**NO:** REL-133  
**DATE:** January 2013

**PRODUCT:** G6K(U)-2□(-Y) Low Signal Relay  
**TYPE:** Product Code Change Notice

## Product Code Change Notice: Surface-Mounting Relay G6K(U)-2□(-Y)

## Additional Marking Changes

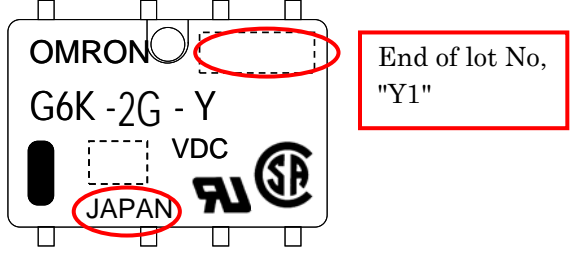
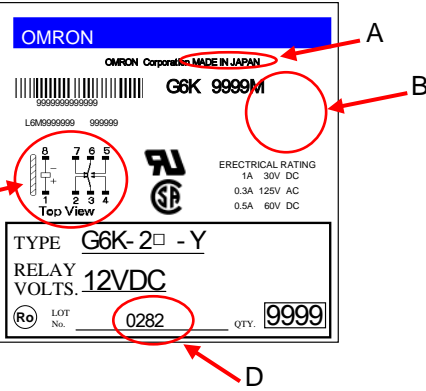
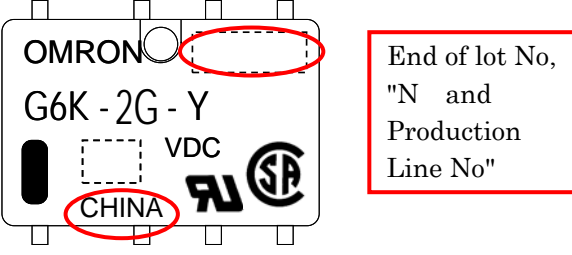
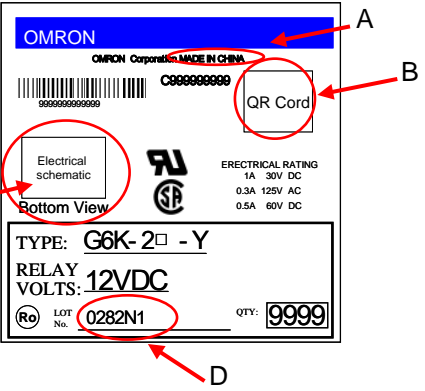
Before the change	After the change
<p><b>The country of origin.</b> MADE IN JAPAN</p> <p><b>Display of the country of origin.</b> MADE IN JAPAN</p> <p>Case Marking</p>  <p>End of lot No, "Y1"</p> <p>Label</p>  <p>Closer detail and Explanation:</p> <ul style="list-style-type: none"> <li>A. MADE IN JAPAN</li> <li>B. No Marking</li> <li>C. Top View (Electrical Schematic)</li> <li>D. LOT No. is only the date of production.</li> </ul>	<p><b>The country of origin.</b> MADE IN CHINA</p> <p><b>Display of the country of origin.</b> MADE IN CHINA</p> <p>Case Marking</p>  <p>End of lot No, "N and Production Line No"</p> <p>Label</p>  <p>Closer detail and Explanation:</p> <ul style="list-style-type: none"> <li>A. MADE IN CHINA</li> <li>B. QR Code</li> <li>C. Bottom View (Electrical Schematic)</li> <li>D. LOT No. is "the date of production" "N" and "Production Line No."</li> </ul>
